Subject: Almond 2 Power Plant (09-AFC-02)  
Data Response Set 1A, Responses to CEC Staff Data Requests 1 through 84 and  
Staff Query 1

# Almond 2 Power Plant

## Data Responses, Set 1A

(Response to Data Requests 1 to 84, and Staff Query 1)

**FIGURE DR13-1**  
**PRELIMINARY HEAT BALANCE DIAGRAM**  
ALMOND 2 POWER PLANT  
CERES, CALIFORNIA

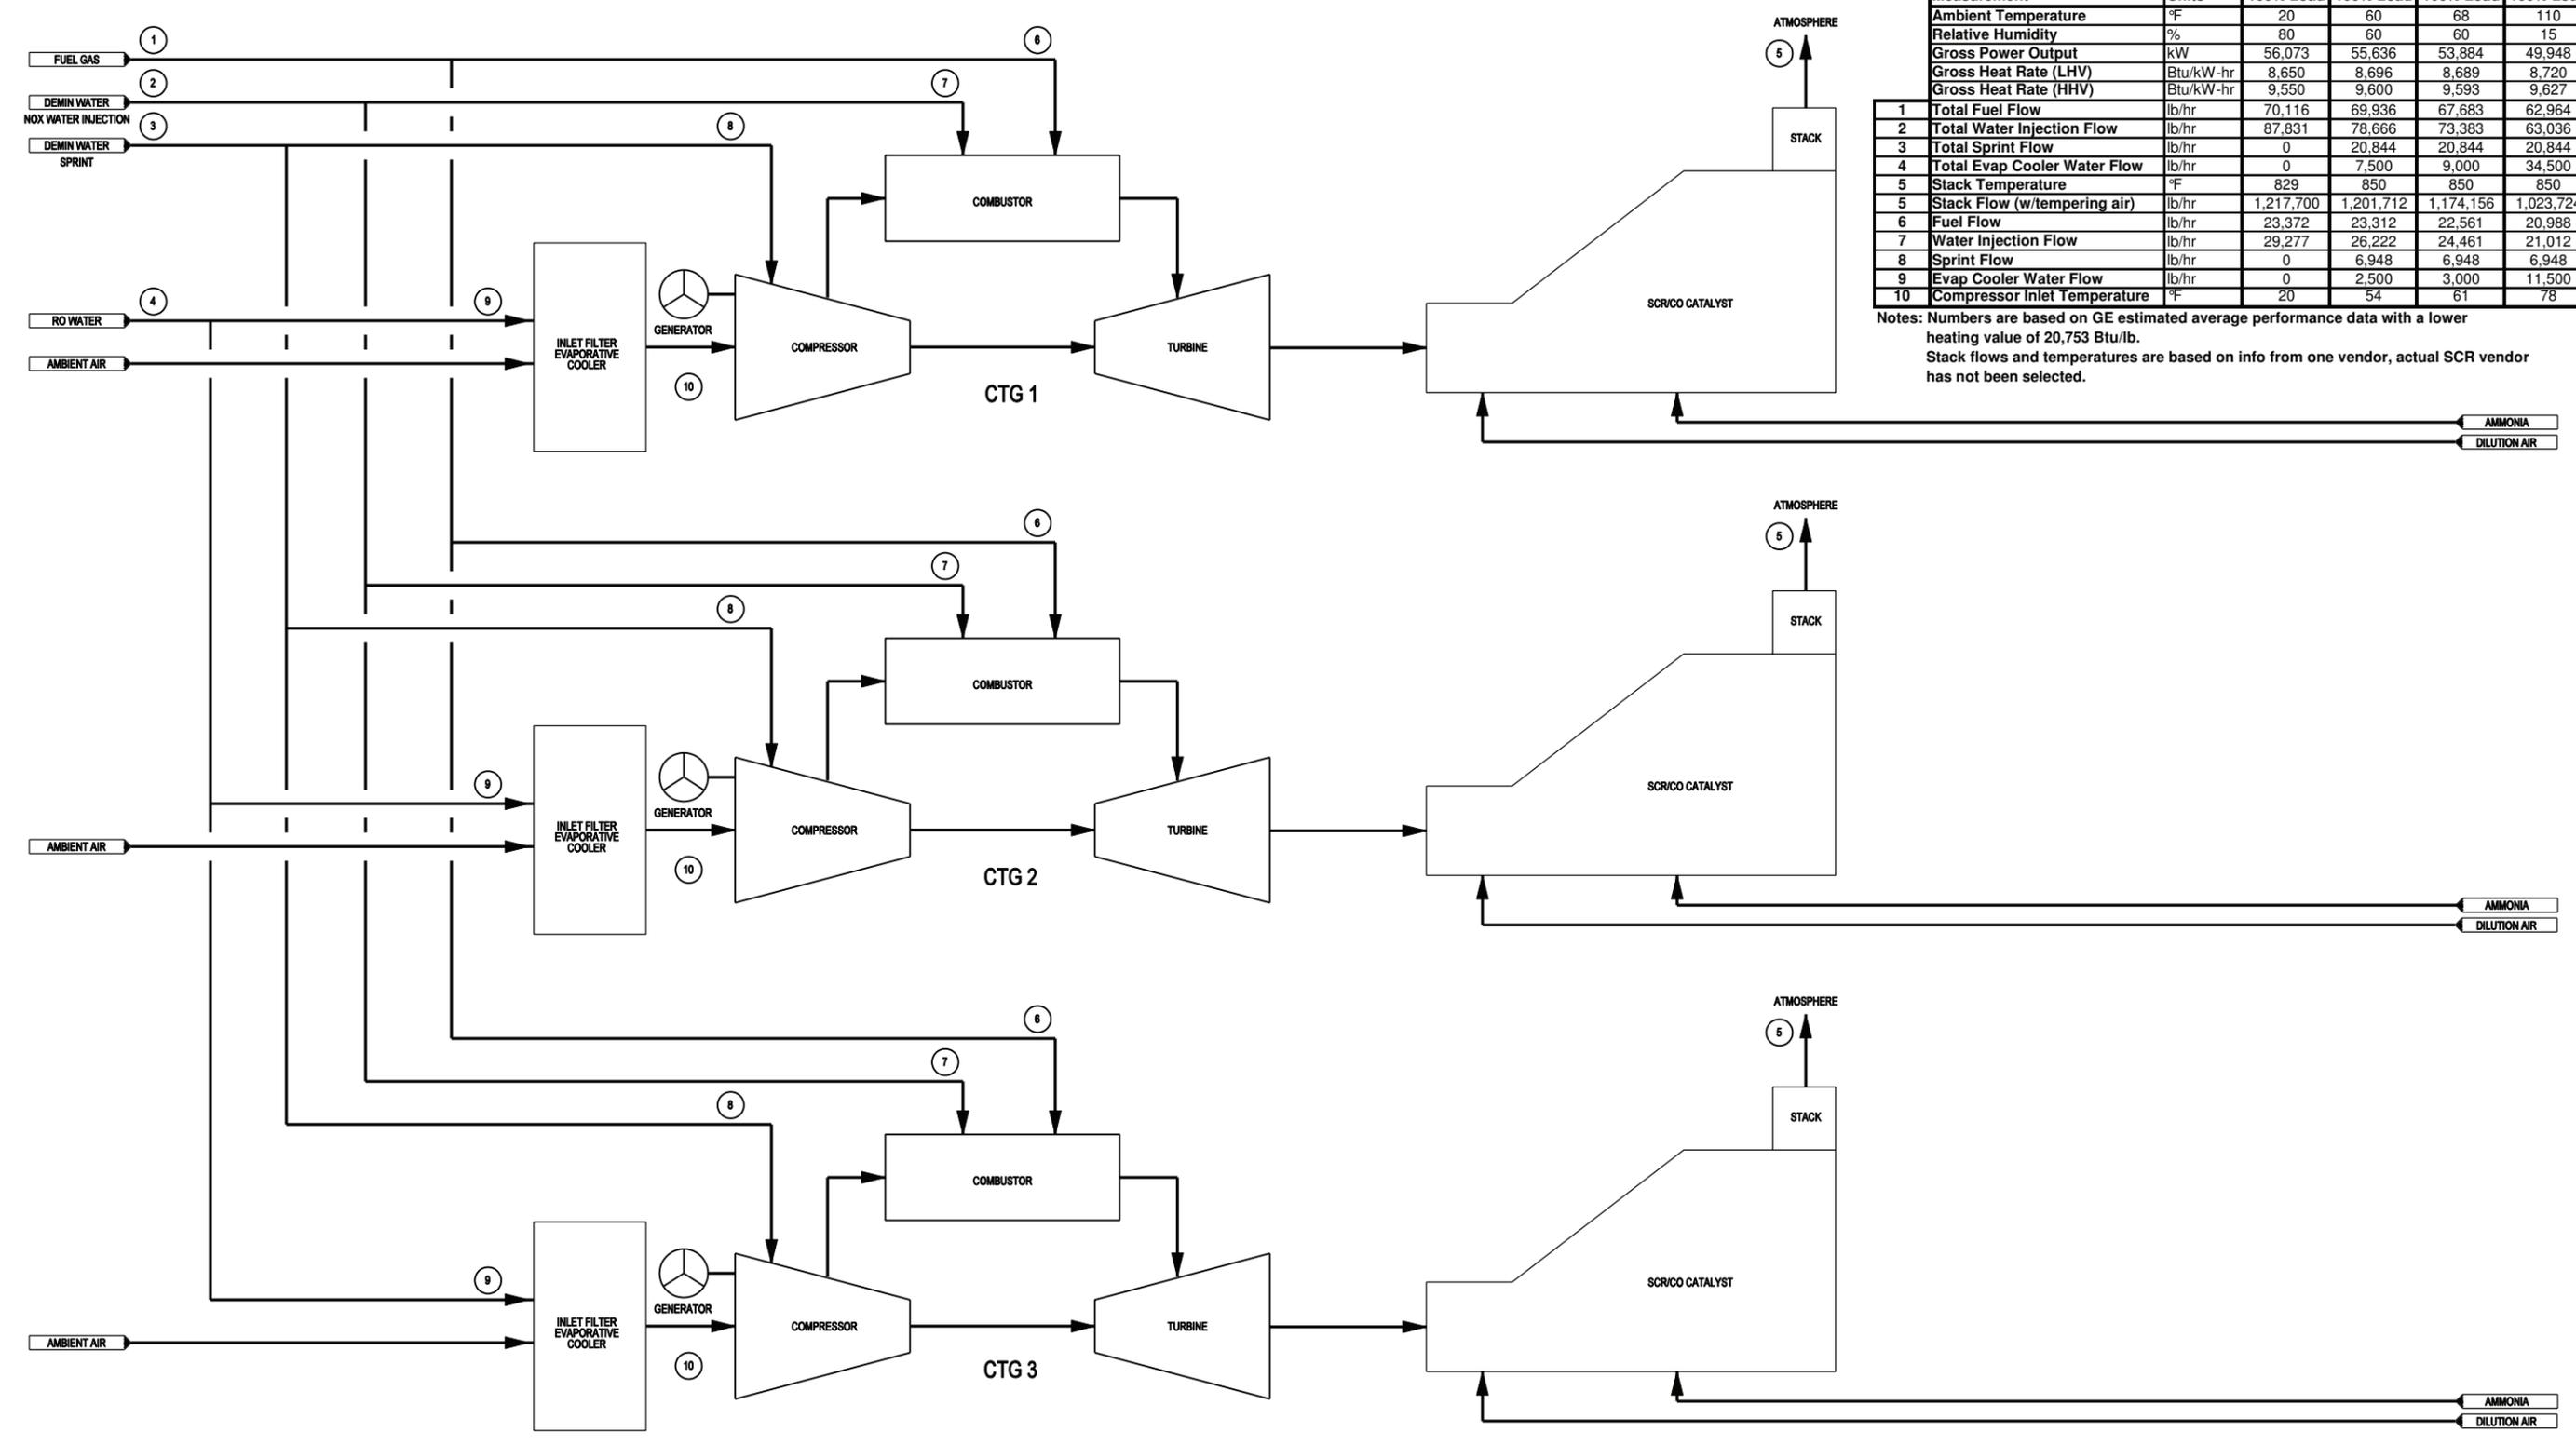
13. Please provide the heat rate information for the proposed combustion turbines (in AFC Project Description, Figure 2.1-3) in terms of higher heating value, to better facilitate comparisons with other power plant data used by staff in determining greenhouse gas impacts.

**Response:** The heat rate information for the proposed combustion turbine is shown in terms of HHV in Table DR13-1 (adapted from Figure 2.1-3 of the AFC).<sup>2</sup>

Figure 2.1-3 has been updated, and is provided as Figure DR13-1, to provide the higher heating values for the various loading conditions.
